Adair-Kennedy Football Field Surveillance System
Supply and Installation

RFQ No. E13-134

ADDENDUM NO.: TWO

DATE ADDENDUM ISSUED: November 14, 2012

SURVEY CONTROL DIAGRAM

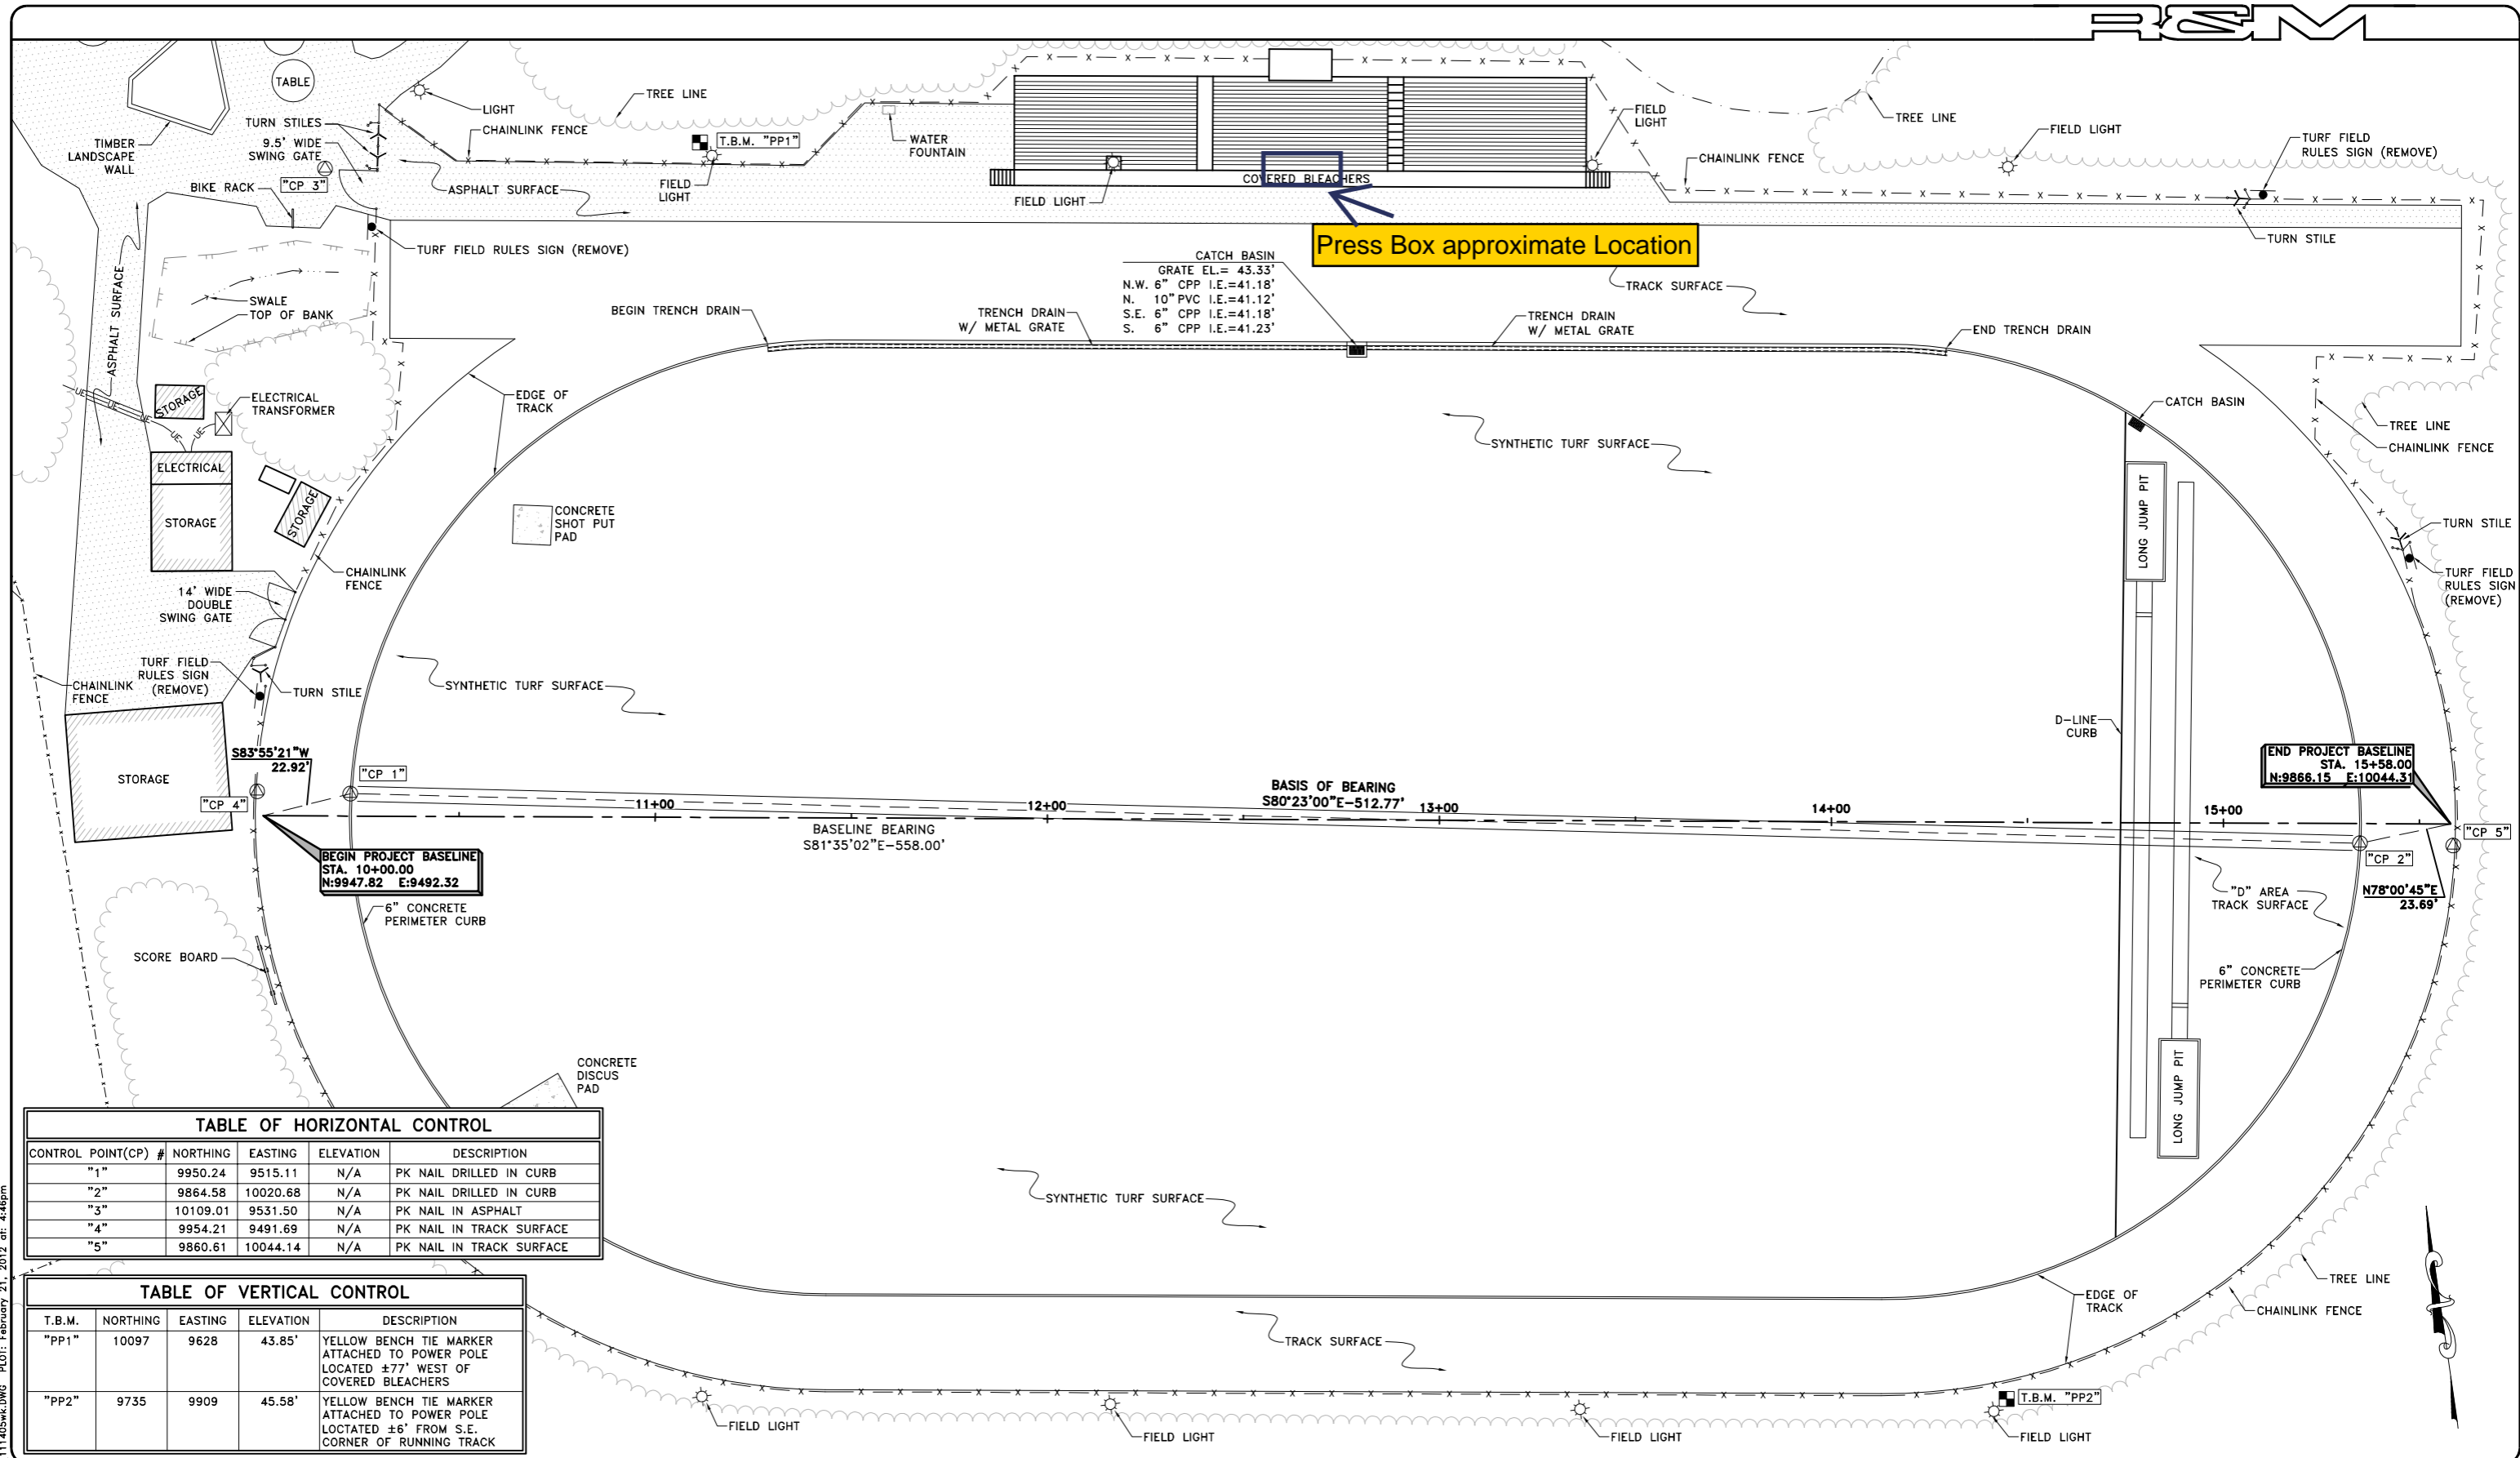
The RFP indicates a "prescribed range" to achieve 61 pixels per sq/ft. What is that range, as I do not see any information? What are the field of view dimensions that are needed (scene height and width) for each camera?

The system must record video at a sufficient resolution to allow facial recognition across the entire field surface. The proposed system must be able to achieve this resolution across a distance of approximately 300 feet. A site plan from a previous project is attached for reference purposes.
